SERVICE 		3
		B0300016

SB, 323 HD 60, 325 HD 60, 325 HD 75, 325 HS 75, 325 HS 99, 325 HDA 55, 325 HE 3, 325 HE 4, 326 HD 60, 326 HD 75, 326 HS 75, 326 HS 99, 326 HDA 55, 326 HE 3, 326 HE 4, Flywheel and clutch yoke, 2003-05

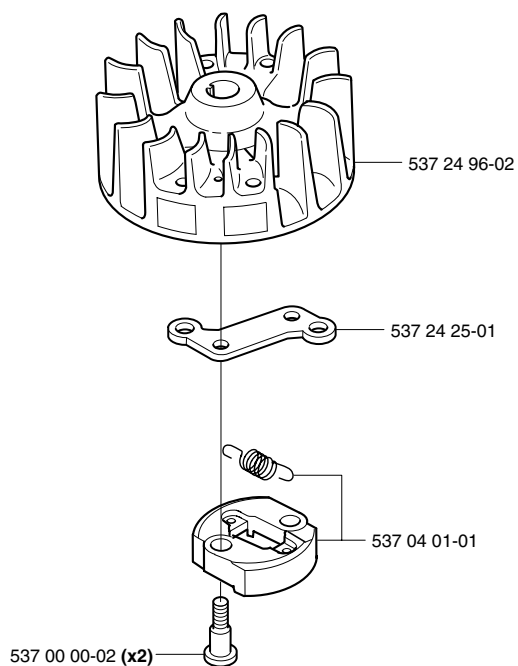
A new version of flywheel has been introduced. The clutch mounting screws now screw straight into the flywheel, instead of into the clutch yoke as before.

From now on, hedge trimmers will therefore not have the same flywheel as trimmers and brushcutters.

New part no.	Description	Excl. part no.	Remark
537 24 96-02	Flywheel	503 87 28-01	*
537 24 25-01	Clutch yoke	537 03 99-01	*
537 00 00-02	Screw	537 00 00-01	*
	Screw	503 21 48-01	*
